AMENDMENTS TO THE DRAWINGS

REMARKS

Title: Redistribution Layer Shielding of a Circuit Element

App. No. 10/814,816

FIG. 5B

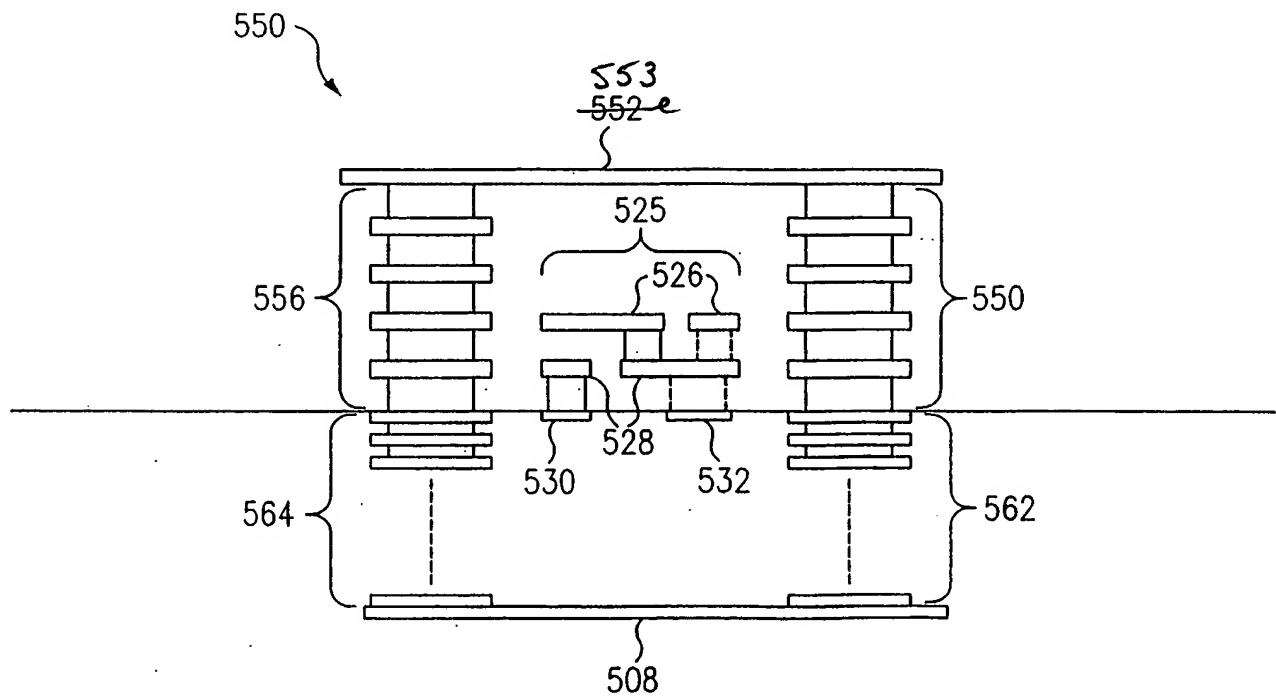
Figure 5B is amended to change the reference numeral of top plate 552 to top plate 553.

The specification is amended to be consistent with the drawings. The specification is amended to change the reference numeral of top plate 552 of FIG. 5B to top plate 553.

FIG. 9A

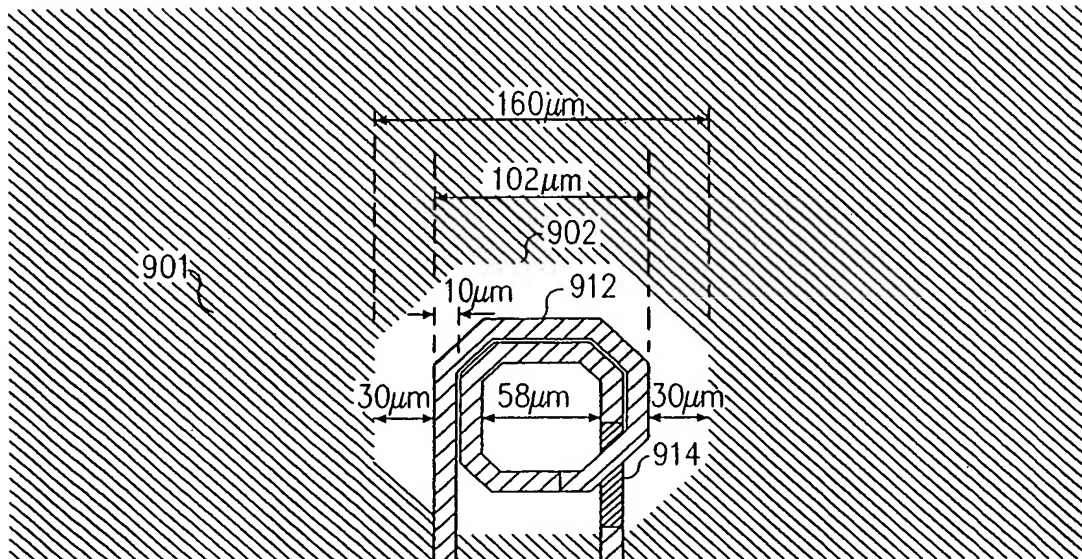
The drawings are objected to as failing to comply with 37 C.F.R. 1.84(p)(5) because they include the following reference characters not mentioned in the description: 1000, 1002, 1004, 1006, 1008, 1010, 1016, and 1066. Figures 9A, 9B, 9C and 10 are amended consistent with the specification.
